**CITY OF SACRAMENTO
DEPARTMENT OF PLANNING & DEVELOPMENT
ZONING ADMINISTRATOR
1231 I Street, Sacramento, CA 95814**

ACTION OF THE ZONING ADMINISTRATOR

On Tuesday, February 7, 1995, the Zoning Administrator approved with conditions a Special Permit for Deep Lot Development to construct two units for the project known as Z94-101. Findings of Fact and conditions of approval for the project are listed on pages 3-6.

Request: Zoning Administrator's Special Permit for Deep Lot Development for three single family detached units on 0.33± vacant acres in the Standard Single Family (R-1) zone.

EXHIBIT - A

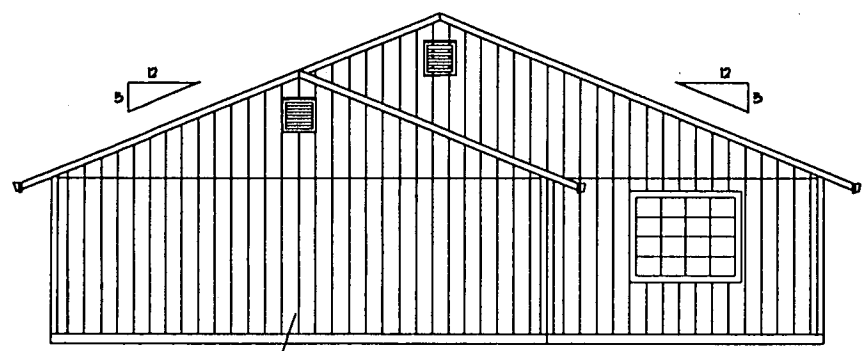
- a. the driveway shall be reduced in width from 20 feet to a maximum of 16 feet (may be reduced to a minimum of 10 feet);
 - b. no mechanical equipment on the roof;

- q. use the proposed third unit floor plan;
 - r. revise the site plan to relocate the second unit further back (at least 20 feet) from the centerline of the property {123 feet from the front property line minimum};

5. The applicant shall coordinate with County Sanitation District No. 1 regarding sanitary sewers {Public Works}.
 6. The corners between the private driveway (serving all units) and each individual driveway shall be rounded to a radius of nine feet {Public Works}.

EXHIBIT - B

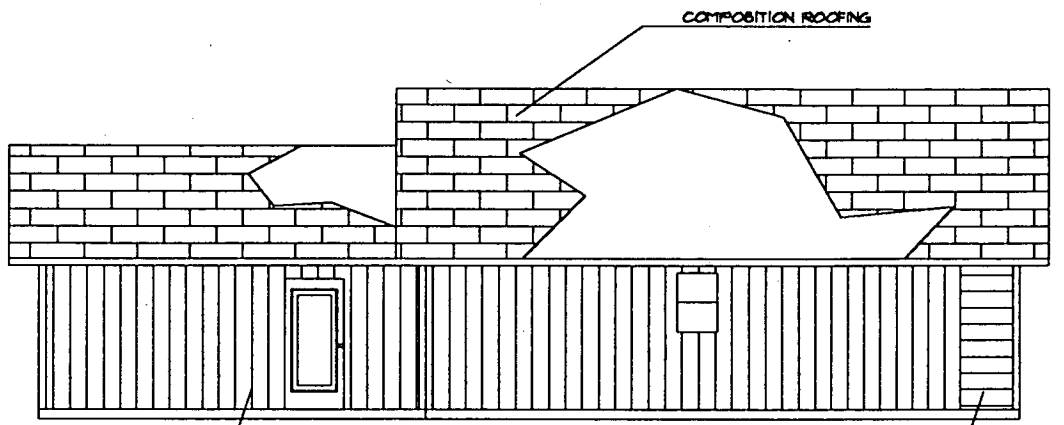
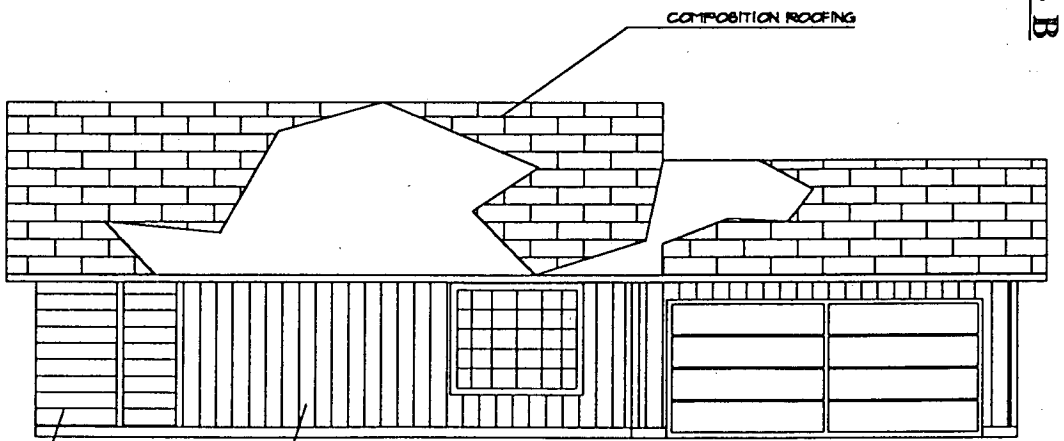
- h. all east elevations shall have horizontal lap siding and the north elevations for the front unit shall have horizontal lap siding;
 - i. a six foot wood fence shall be provided along the north and south property lines from the front setback to the rear of the property and across the rear (west) property line and in the southwest corner of the front unit. A fence shall also be provided between the units to provide private yard area (this fence does not need to be six feet in height). All fencing shall meet the Zoning Ordinance requirements; specifically, no solid fence or chain link fence taller than three feet in the front setback area or higher than six feet any where else. If a gate is installed across the driveway, it shall be setback a minimum of 20 feet from the east property line per City Code. {Fencing shall be installed prior to Final Inspection};

- l. add a window to the dining room near northeast corner on north elevation;

- m. add louvered shutters to both windows on east elevation;
- n. create a slight projection of the gable (a few inches beyond the main wall) on the east elevation;
- o. use 30 year laminated dimension composition shingles;
- p. create a porch element (talk to Randy Lum at 264-5896);

EXHIBIT - D

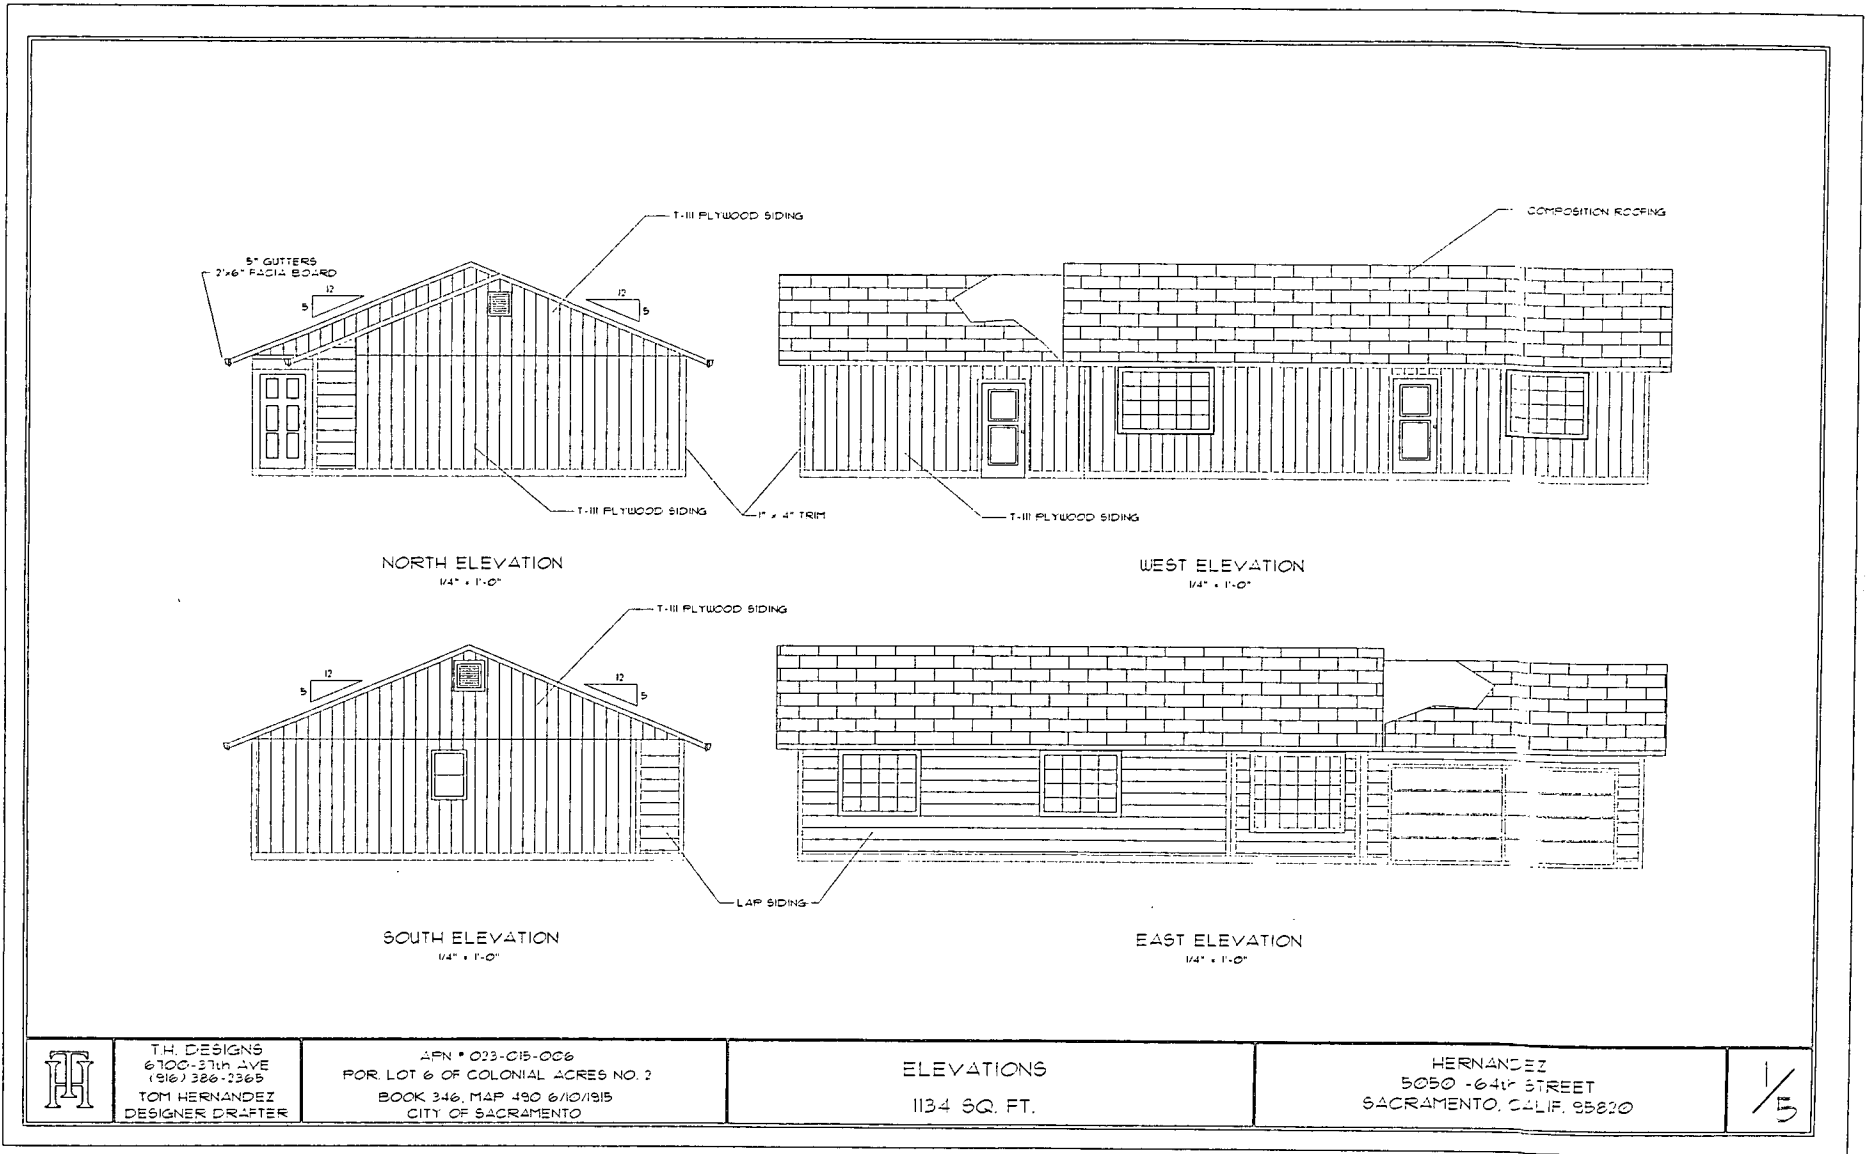
- s. provide a turn around maneuvering pad out of turf block located a minimum of 10 feet from the front of the second unit;
 - t. revise the south elevation to include eliminating the rear door from the house, relocate the dining room window to the kitchen area, and provide a sliding glass door in the location of the dining room window;

EXHIBIT F

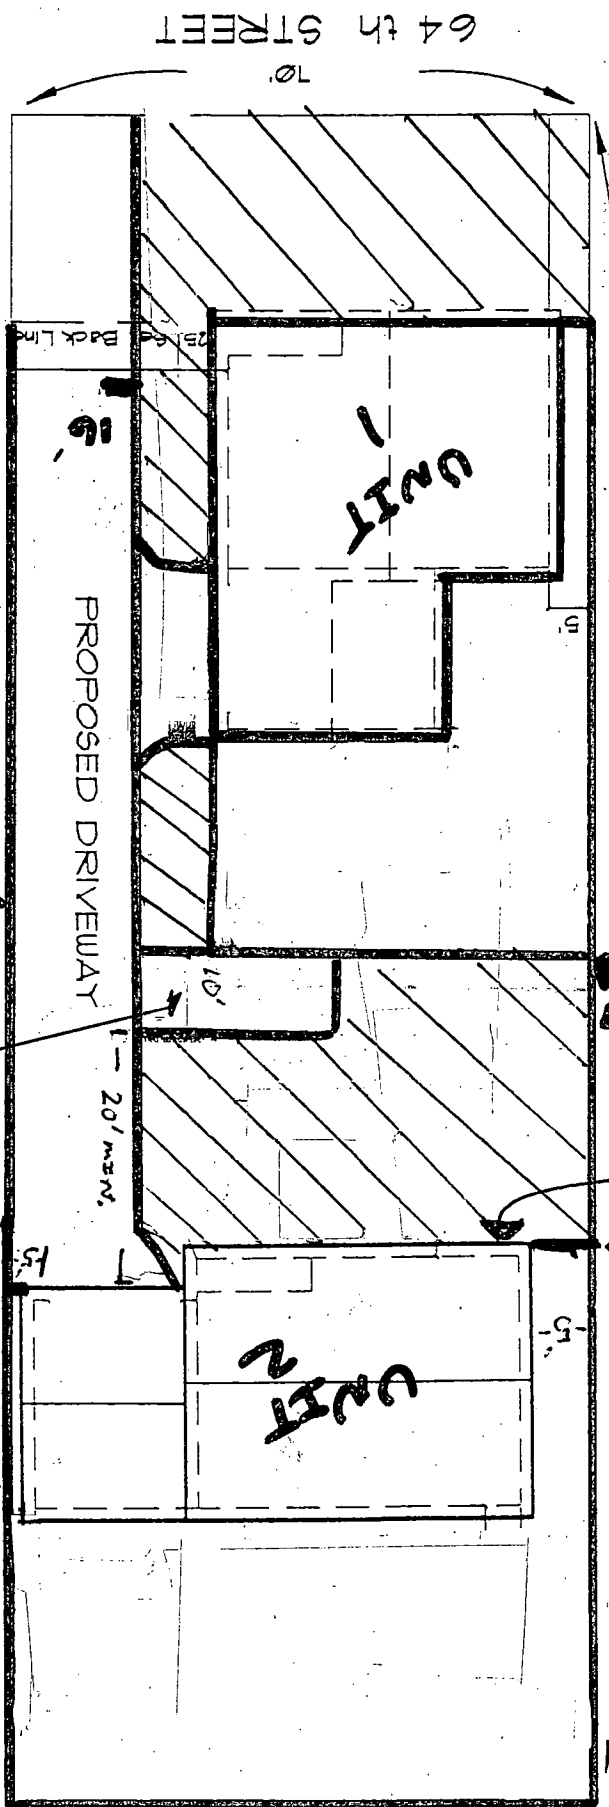
- j. there shall be no parking of vehicles, dumping, or non-enclosed storage on the vacant rear section of the lot;
 - k. the front area of each unit shall be landscaped with sod, shrubs, at least one tree, and irrigated with an automatic sprinkler system (see Staff Exhibit F);

EXHIBIT H

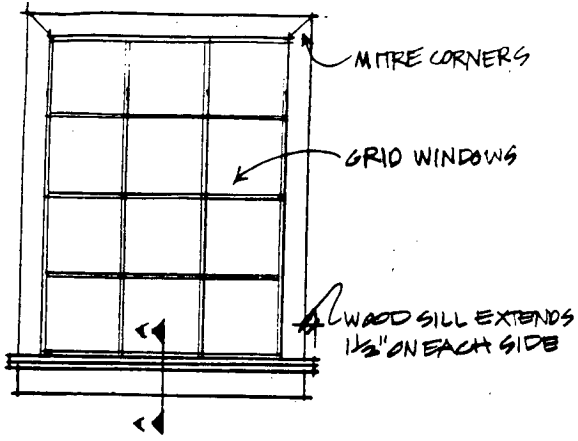
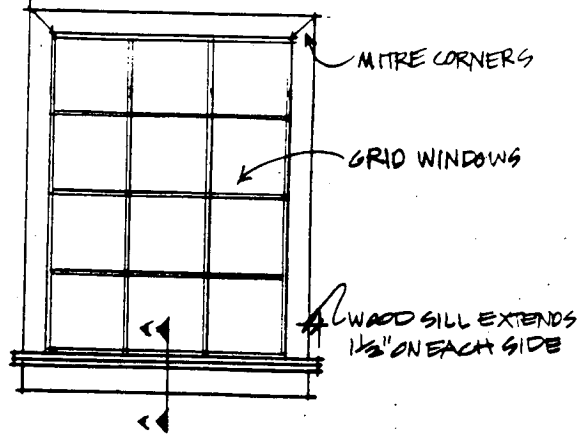
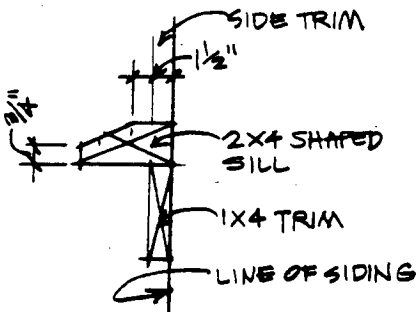
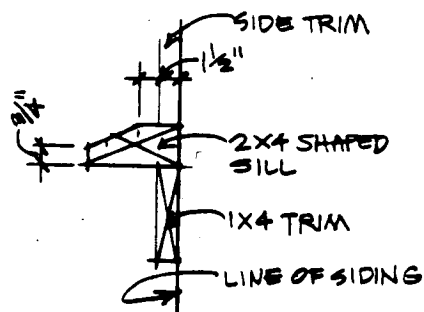
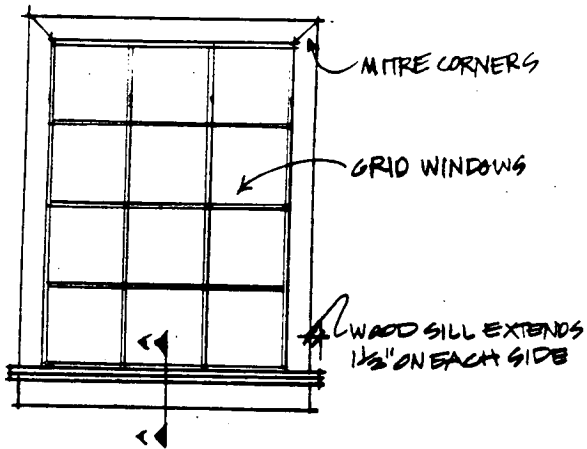
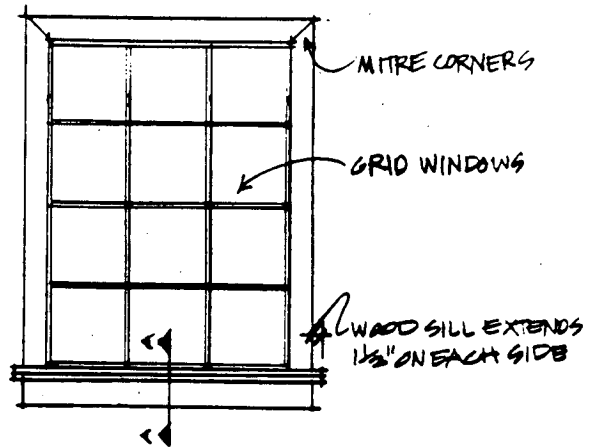
- c. all garage doors shall be metal sectional doors subject to Planning staff review;
 - d. all windows shall have the window treatment as indicated by Design Review (see Staff Exhibit H);
